Product Change Notice (PCN)

PCN Number: **PCN-0451100R-02**

Product(s) Affected: SJD1-3201-54

| PREVIOUS CUI DEVICES DETAIL / IMAGE | NEW CUI DEVICES DETAIL / IMAGE |
|--|---|
|  <p>Recommended PCB Layout Top View</p> |  <p>Recommended PCB Layout Top View</p> |

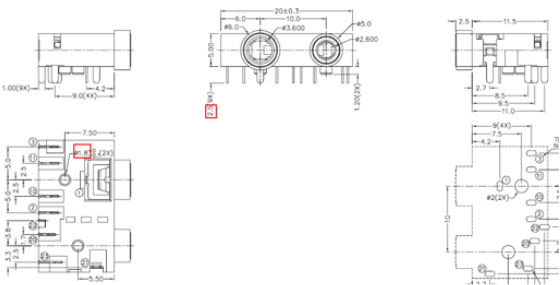
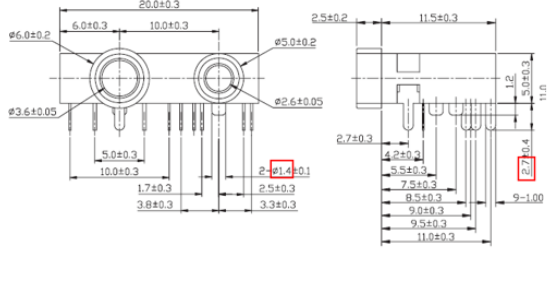
Description of Change: mechanical and material differences as shown below:

| | MATERIAL | PLATING | DESCRIPTION | MATERIAL | PLATING/COLOR |
|-------------|--------------|---------|-------------|---------------------------|---------------|
| terminal 2 | copper alloy | tin | terminal 2 | stainless steel t=0.20 | tin |
| terminal 3 | copper alloy | tin | terminal 3 | stainless steel t=0.20 | tin |
| terminal 21 | copper alloy | tin | terminal 21 | phosphor bronze t=0.30 | tin |
| terminal 22 | copper alloy | tin | terminal 22 | stainless steel t=0.20 | tin |
| terminal 23 | copper alloy | tin | terminal 23 | phosphor bronze t=0.25 | tin |
| plastic | PBT | | housing | PAB6+GF15% (UL94HB) | black |
